## Proposal for amendments to the draft Pole Side Impact GTR

The text reproduced below was prepared by the expert from the United States. This proposal is based on ECE/TRANS/WP.29/GRSP/2013/120.

#### ➤ Shoulder injury risk AIS2+

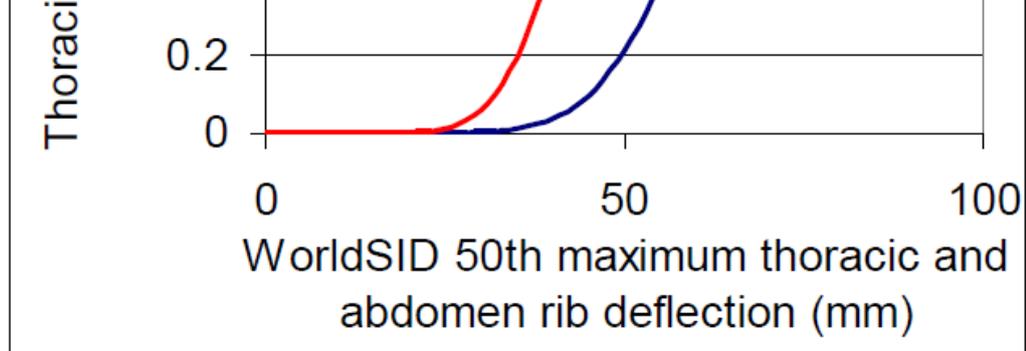
Maximum shoulder Y force (N)	5% AIS2+	quality index at 5% AIS2+	25% AIS2+	quality index at 25% AIS2+	50% AIS2+	quality index at 50% AIS2+
45 year old	1799	fair	2270	fair	2556	fair
67 year old	1594	good	2011	good	2265	good

➤ Thoracic skeletal injury risk AIS3+

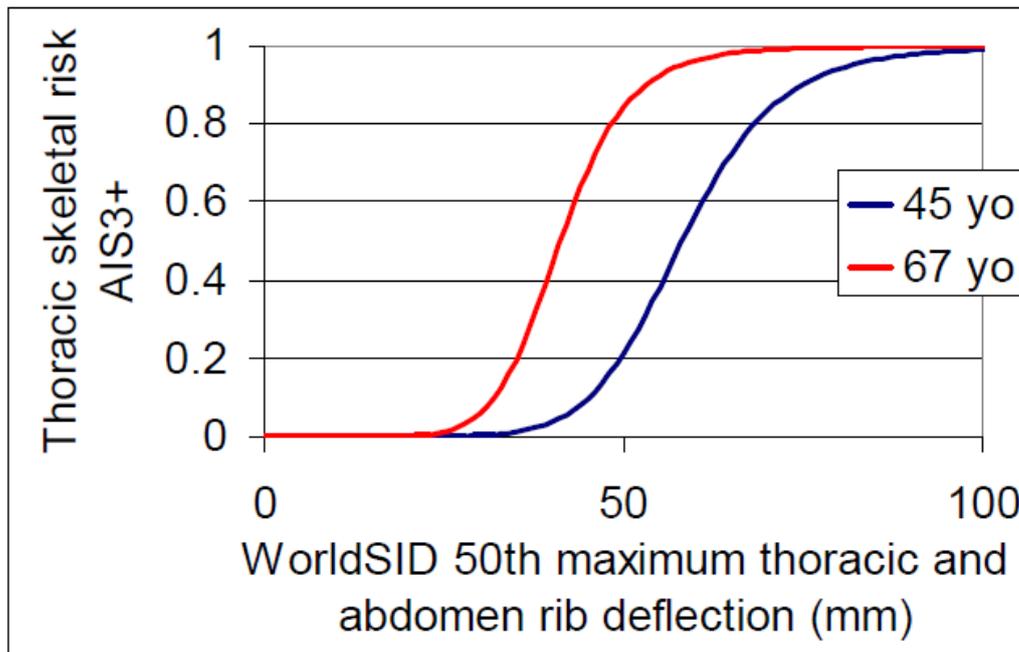
Maximum thorax and abdomen rib deflection (mm)*	5% AIS3+	quality index at 5% AIS3+	25% AIS3+	quality index at 25% AIS3+	50% AIS3+	quality index at 50% AIS3+
45 year old	41.4	fair	51.2	fair	58.1	good
67 year old	29.3	fair	36.3	good	41.2	good

### ➤ Abdomen injury risk AIS2+

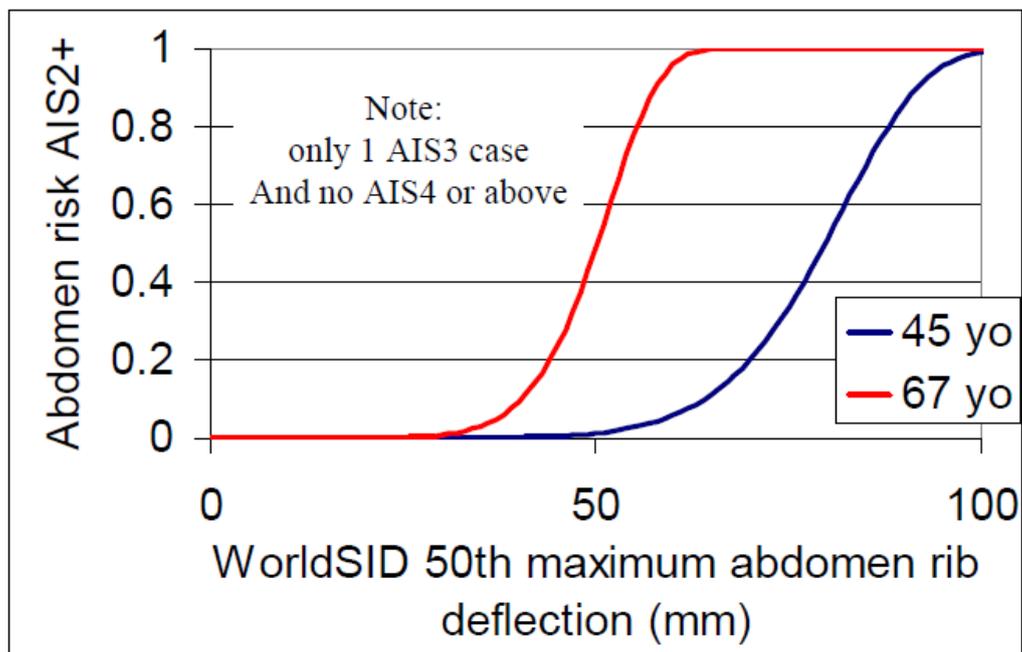
Maximum abdomen rib deflection (mm) *	5% AIS2+	quality index at 5% AIS2+	25% AIS2+	quality index at 25% AIS2+	50% AIS2+	quality index at 50% AIS2+
45 year old	58.9	fair	72.0	fair	79.8	fair
67 year old	37.1	fair	45.3	good	50.2	good

➤ Pelvis injury risk AIS2+

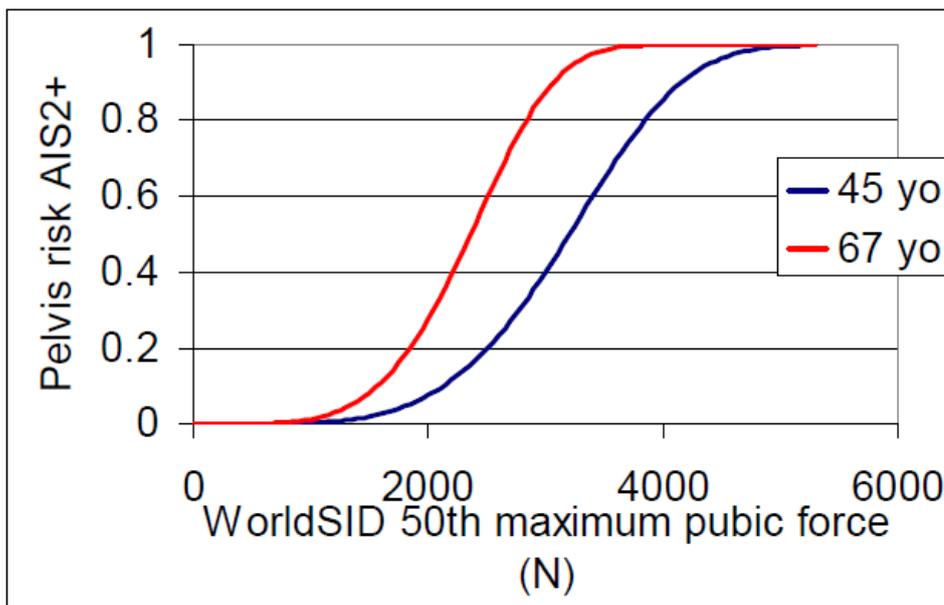
Maximum pubic force (N)	5% AIS2+	quality index at 5% AIS2+	25% AIS2+	quality index at 25% AIS2+	50% AIS2+	quality index at 50% AIS2+
45 year old	1818	fair	2645	marginal	3202	marginal
67 year old	1340	fair	1950	good	2361	good

➤ Pelvis injury risk AIS3+

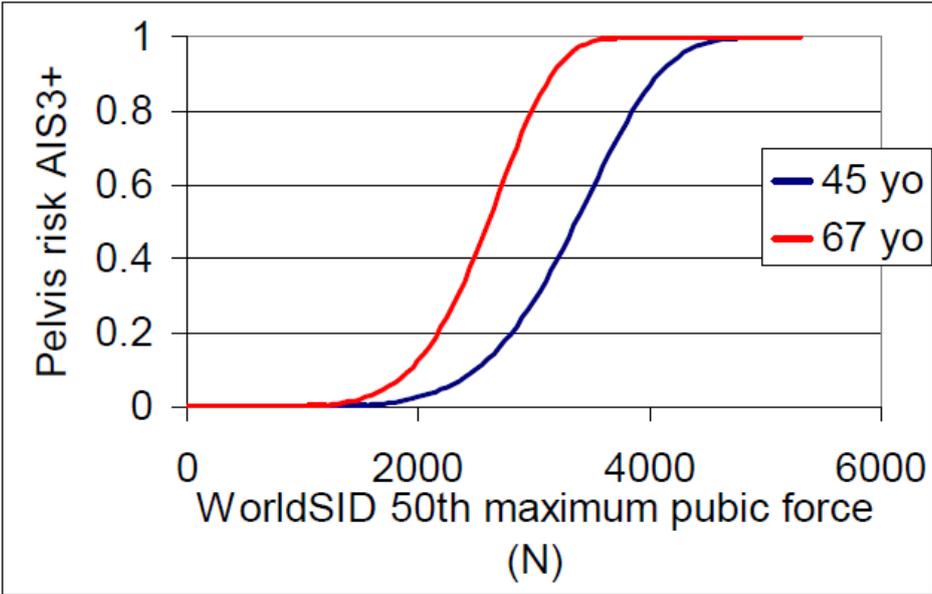
Maximum pubic force (N)	5% AIS3+	quality index at 5% AIS3+	25% AIS3+	quality index at 5% AIS3+	50% AIS3+	quality index at 5% AIS3+
45 year old	2214	marginal	2922	marginal	3365	marginal
67 year old	1714	good	2262	good	2605	good
